RE: **Winrock Road Town Center**
2100 Louisiana Blvd NE
Drainage Master Plan- Drainage Implementation Plan
Engineer's Stamp Date: 5/16/19
Hydrology File: J19D058

Based on submittal received on 5/17/19, the Drainage Implementation Plan cannot be approved for Site Plan for Building Permit until the following are corrected:

RE: Winrock Town Center Drainage Implementation Plan
Hydrology File: J19D058

WINROCK TOWN CENTER DRAINAGE IMPLEMENTATION PLAN

WINROCK TOWN CENTER PHASE B INFRASTRUCTURE IMPROVEMENTS			
TITLE: STORM DRAIN AP-D 300			
Design Review Committee	City Engineer	Ms./Day/Yr.	
		Ms./Day/Yr.	
City Project No.	Zone Map No.	Sheet	Of
4553.90	J-19-Z		
		EXHIBIT 6

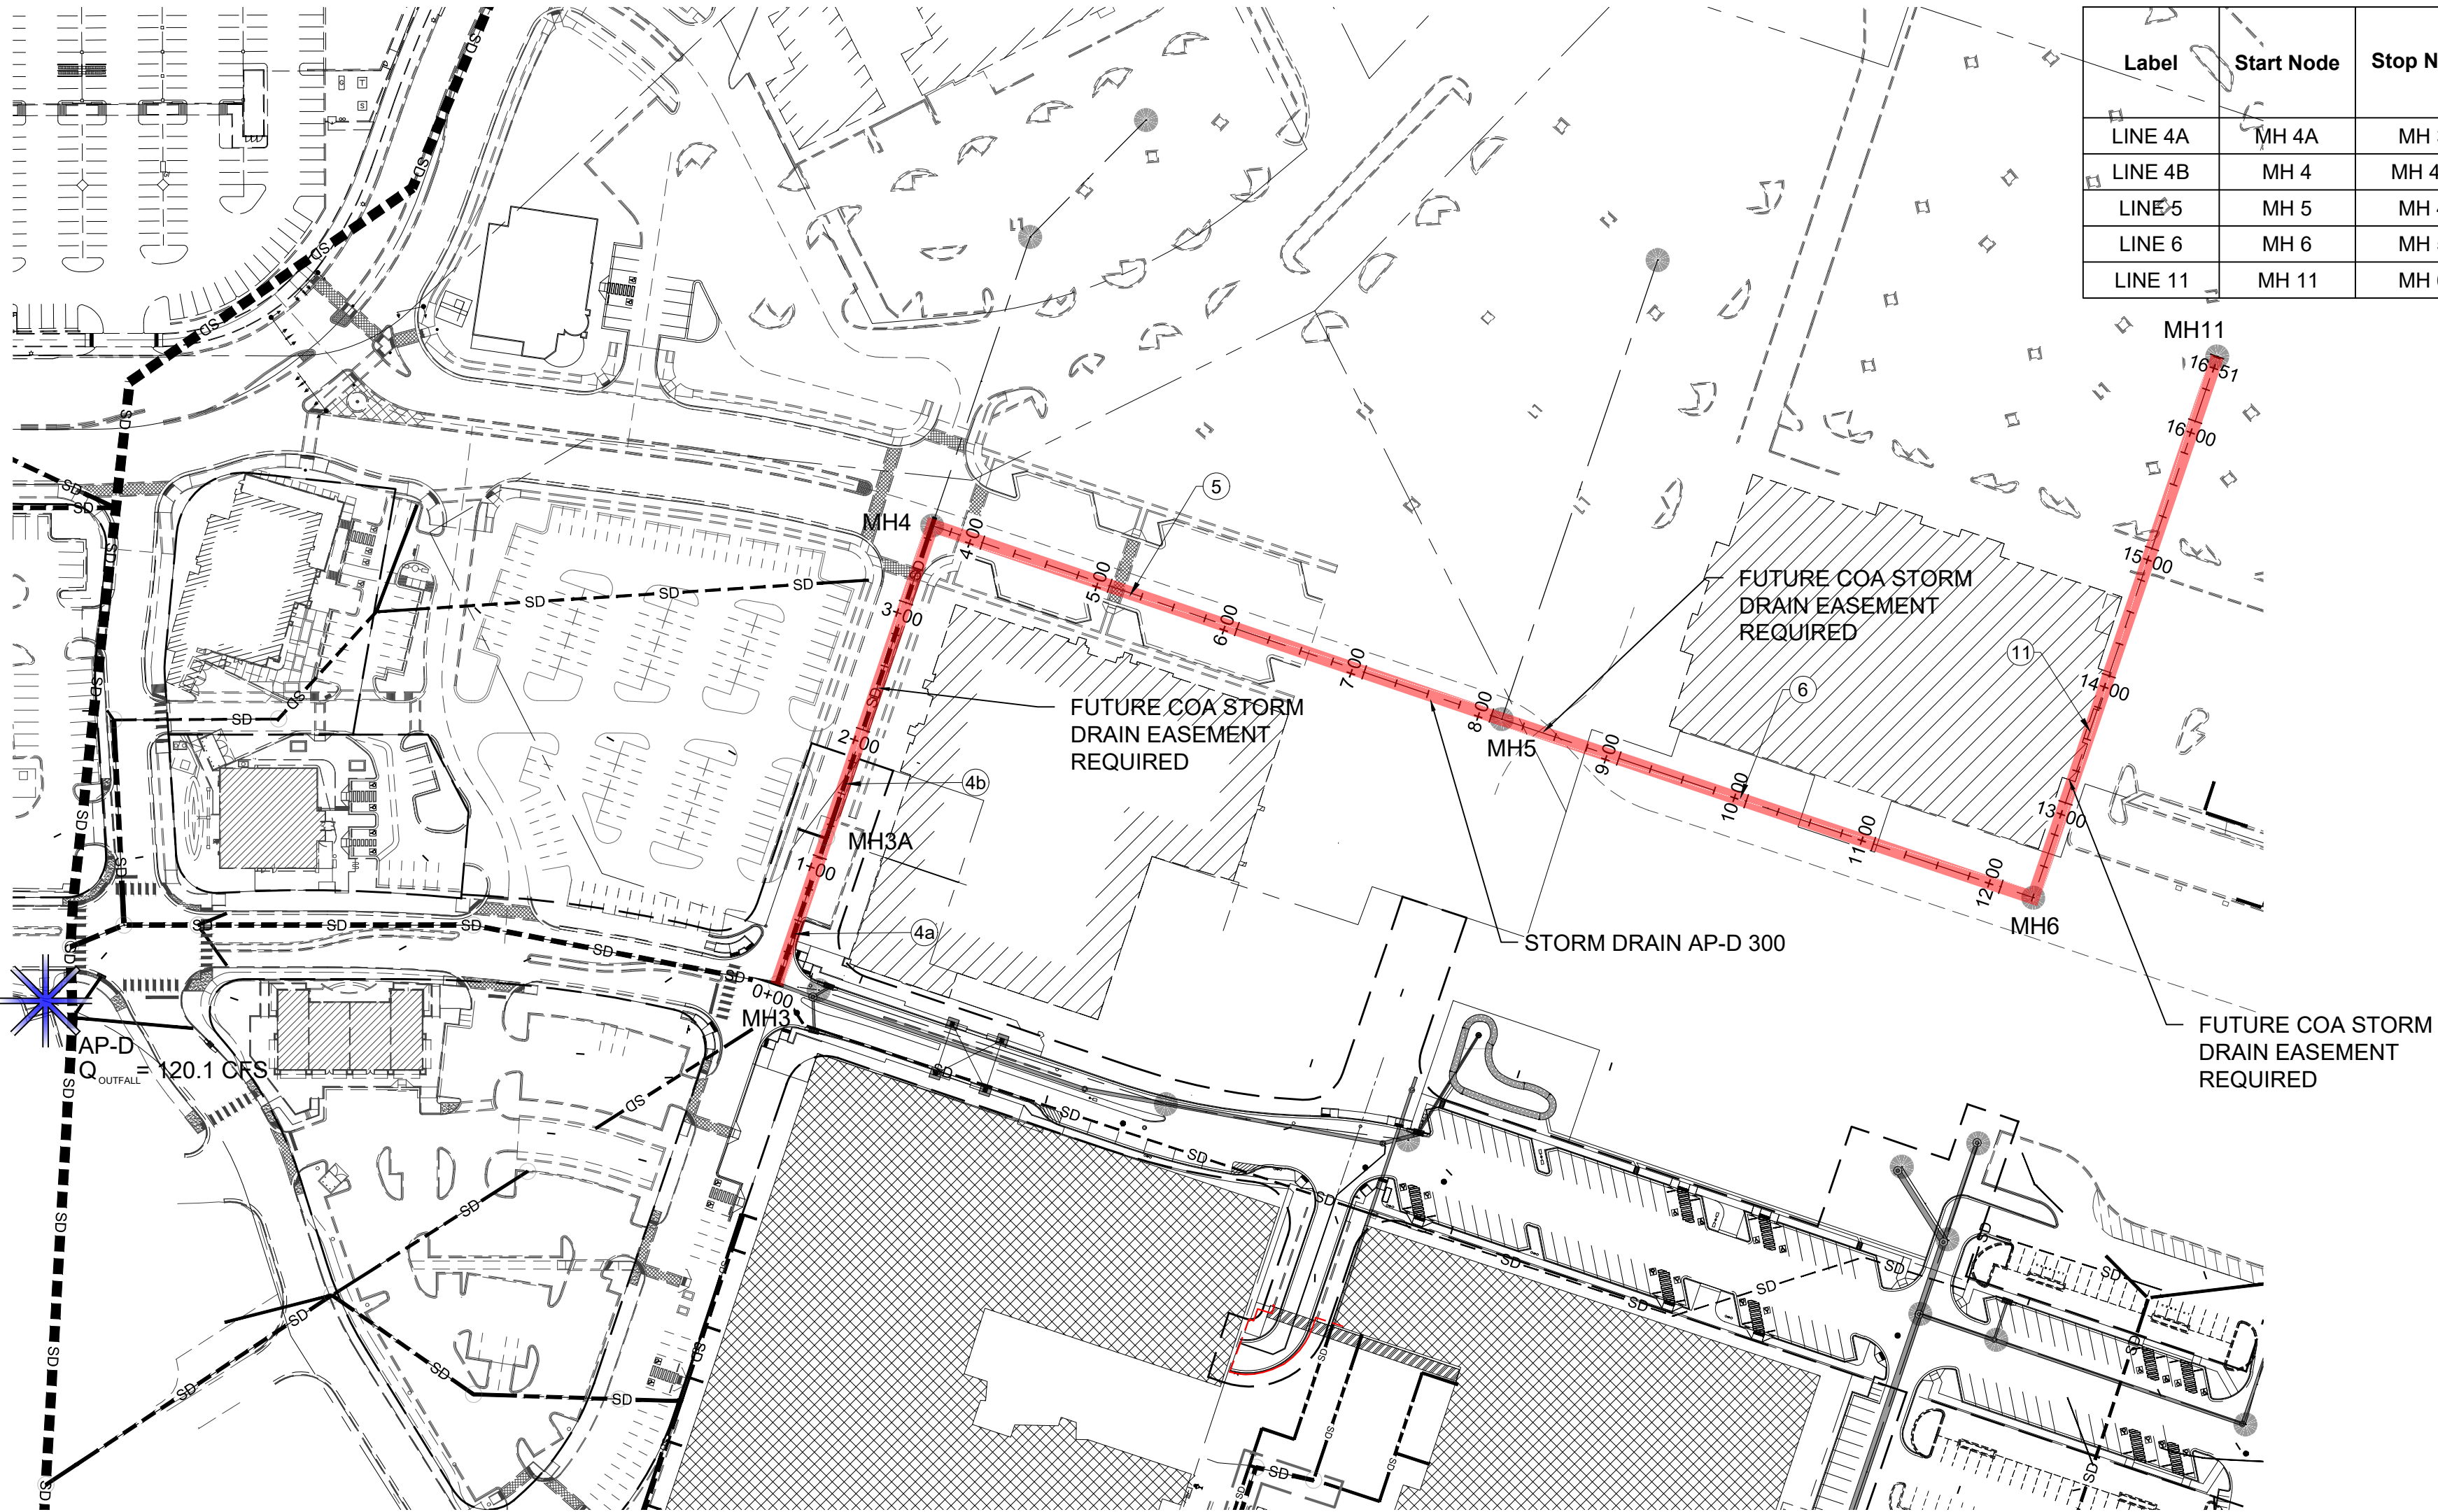
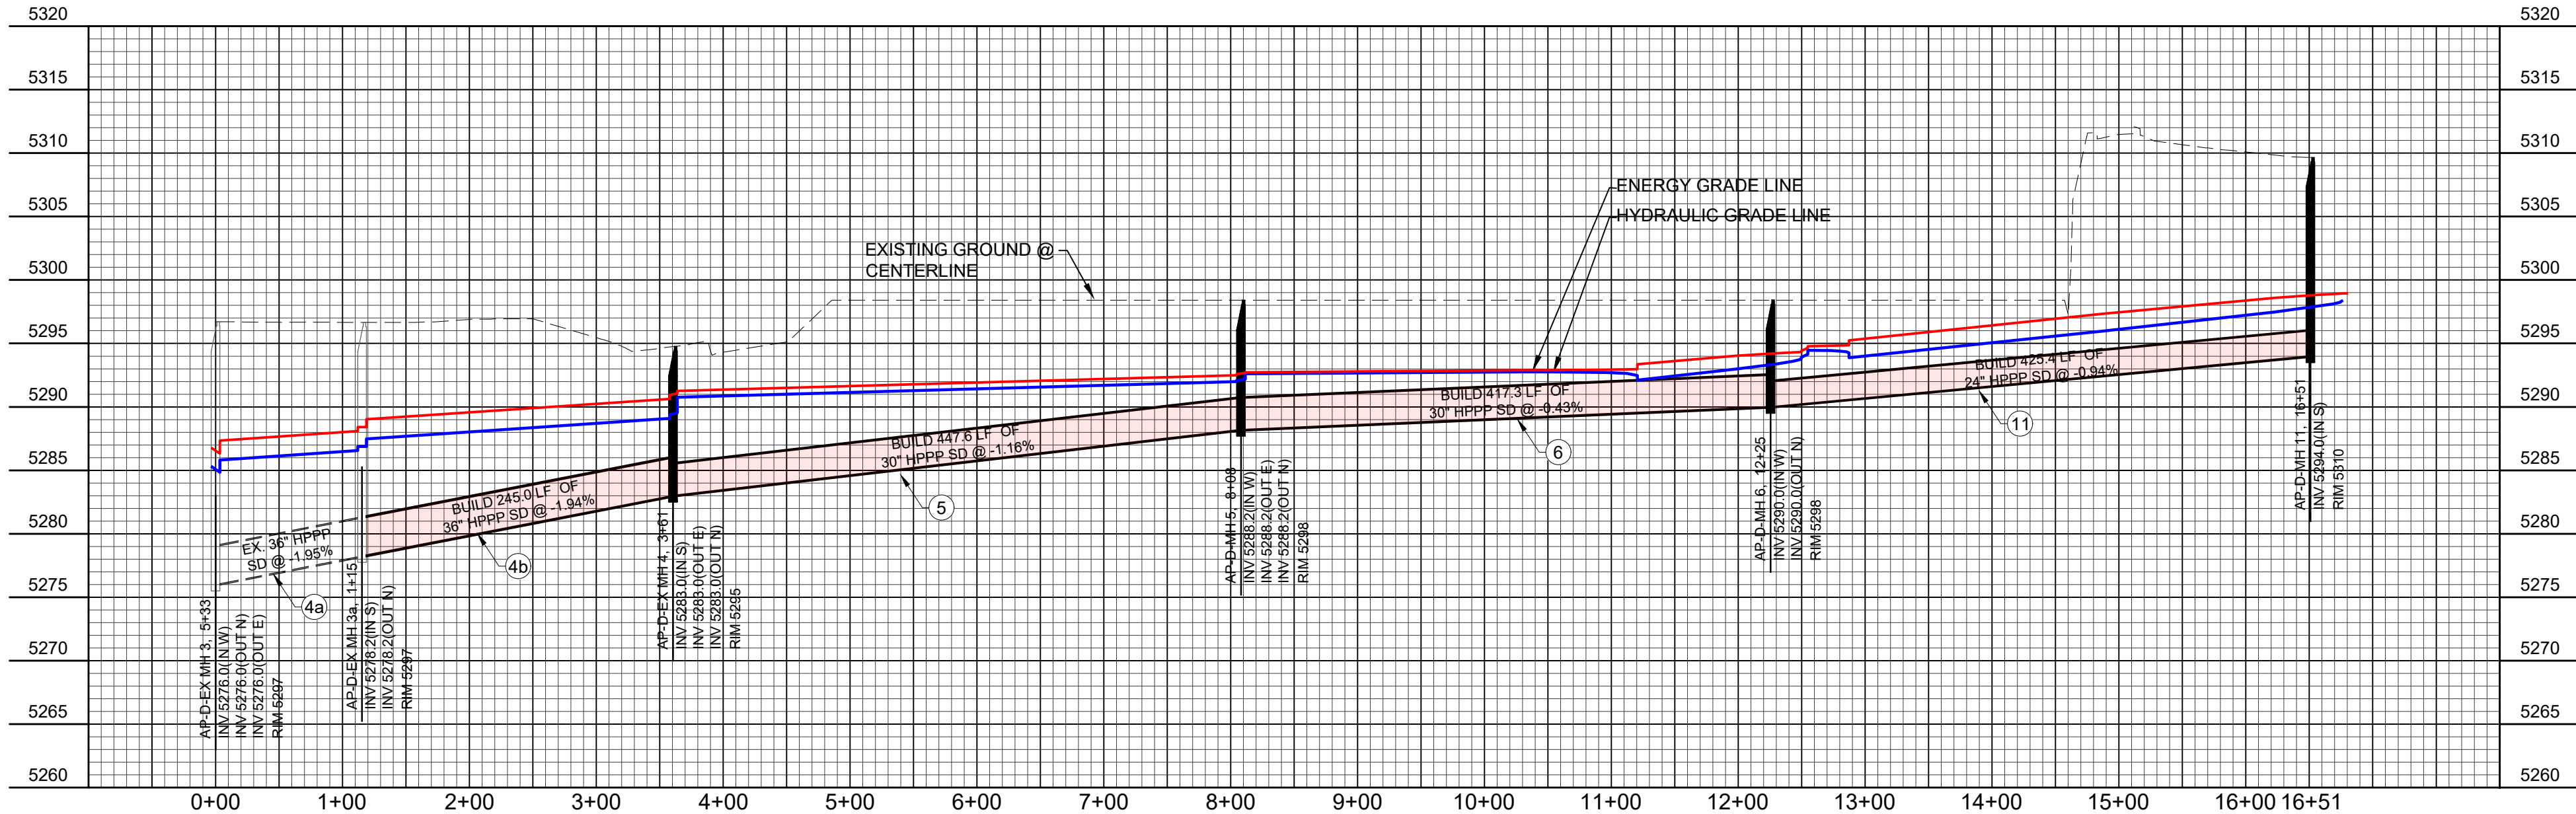
- f. On Exhibit 6, pipe 6 is called out as 30" in profile and 30" on the exhibit 1 table, but is 24" in the table.
 - g. On Exhibit 7, pipe 8 is called out as 30" in profile, but is 36" in the table and 36" on the exhibit 1 table
